St.Michael's, Manchester
Proposed Changes, March 2022

This document is a page by page comparison of the approved Section 73 drawings alongside the amended which forms part of the proposed Section 96a Application.

LEVEL 06 GA PLAN

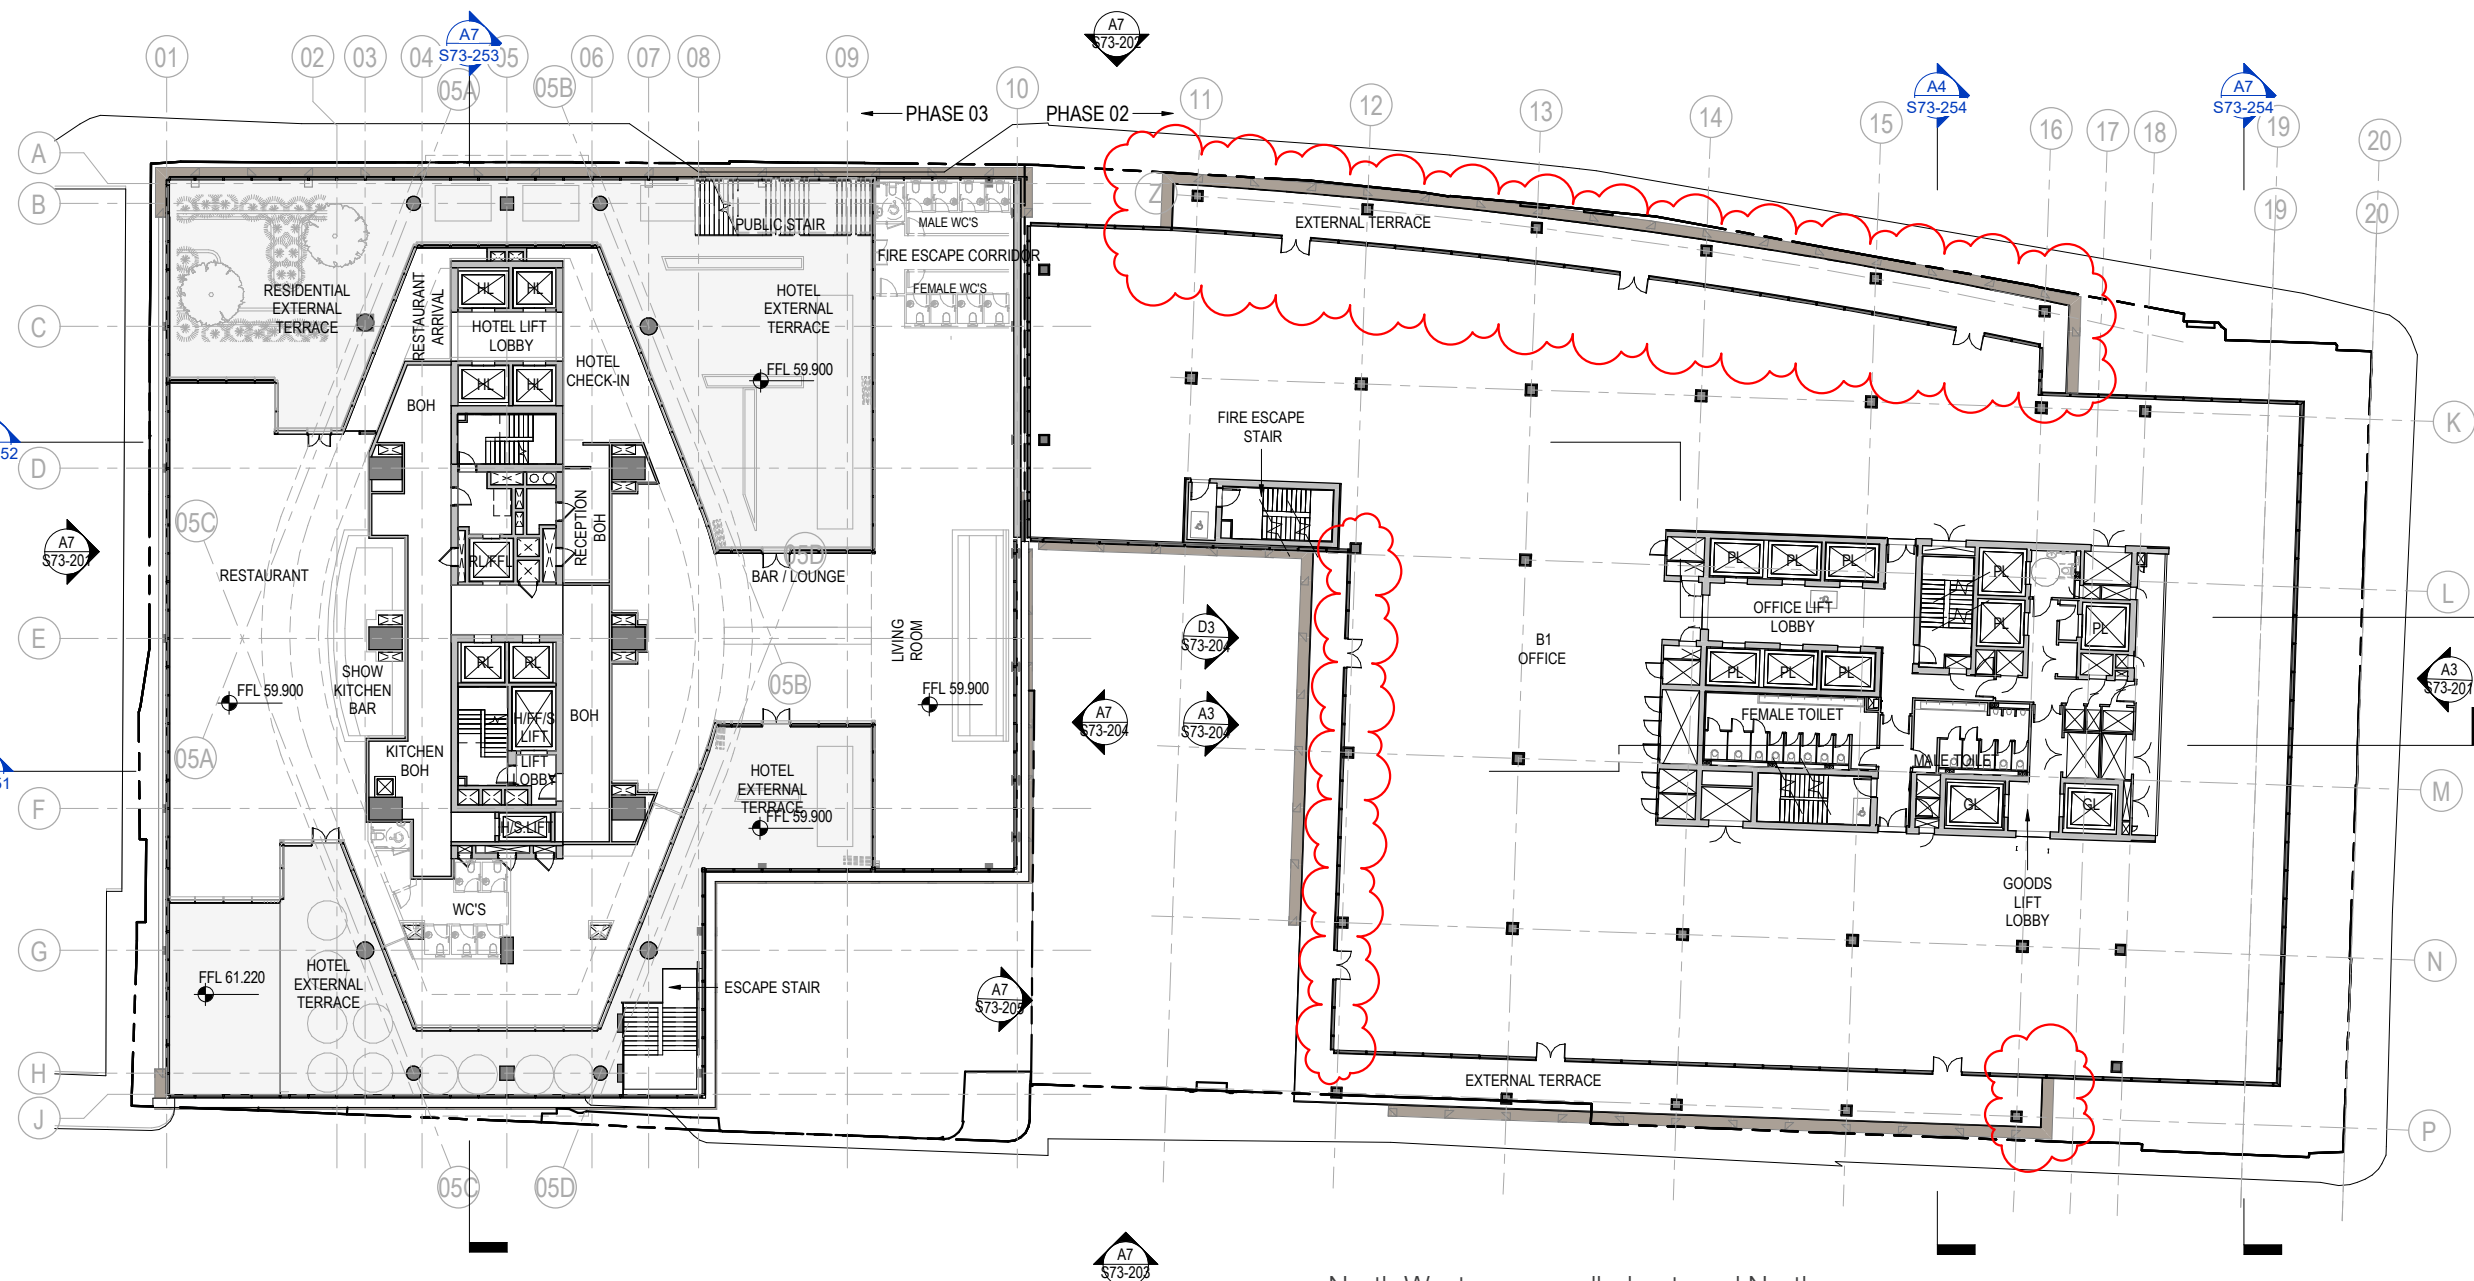
- + North West corner pulled out, and North East and South corners pushed in to reposition area to develop repeated glass to glass corner detail
- + Inset terrace positions amended to bring columns internal
